Service Bulletin

Bulletin No.: 17-NA-184

Subject: Information on Proper Oil Filter Usage

ACDelco PF2257G

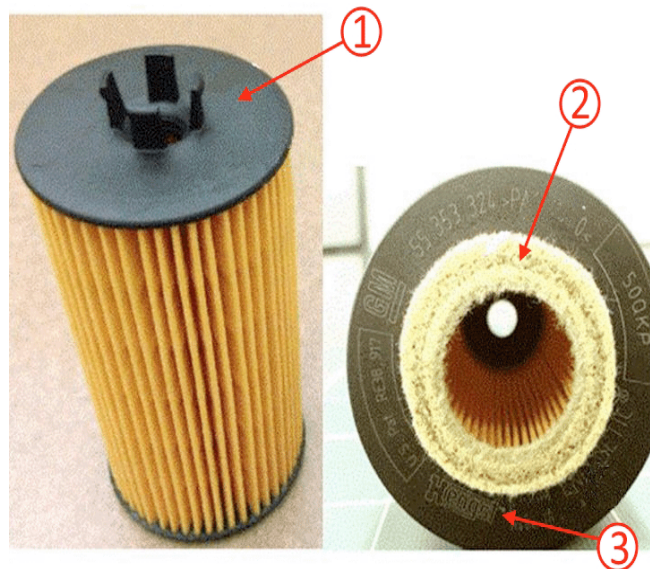
Important: These engines are affected by an oil filter and filter housing supplier change mid production (Hengst to UFI). The oil filter elements for the housings are not interchangeable. It is critical to confirm the correct oil filter is being used, otherwise the oil filter may be bypassed entirely. The VIN alone is not sufficient for oil filter application confirmation.

Identification
1	No Ribs
2	Felt style gasket/seal
3	Supplier Name: Hengst
4	Bypass valve in housing

Identification
1	Cap: Black
2	Supplier Name: Hengst
3	Circumference: Smooth
USE PF2257G Filter

ACDelco PF2263G

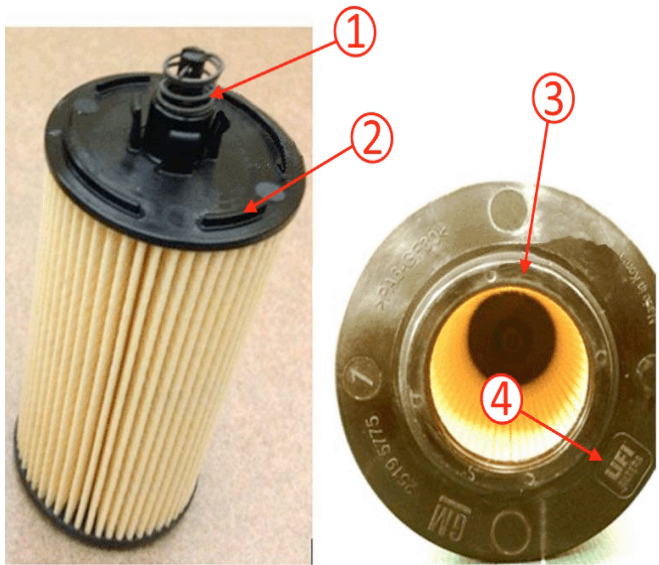
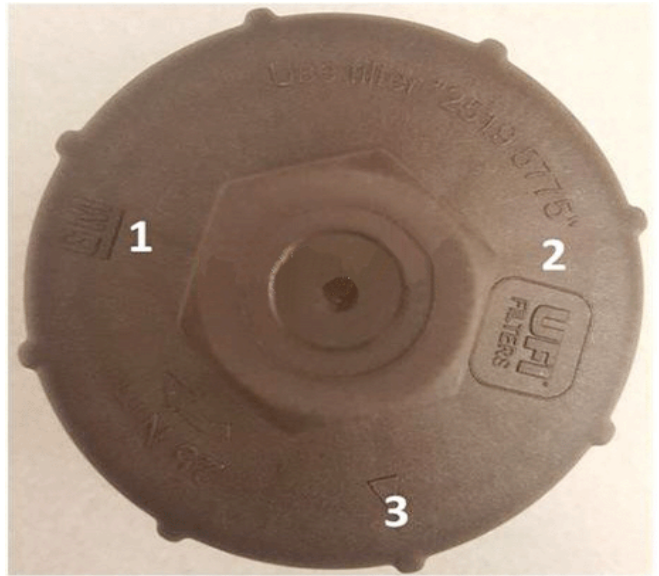
Identification
1	Bypass valve in filter
2	4 spacers/Ribs
3	O-Ring style gasket/seal
4	Supplier Name: UFI

Identification
1	Cap: Dark Brown
2	Supplier Name: UFI
3	Circumference: Ribbed
USE PF2263G Filter
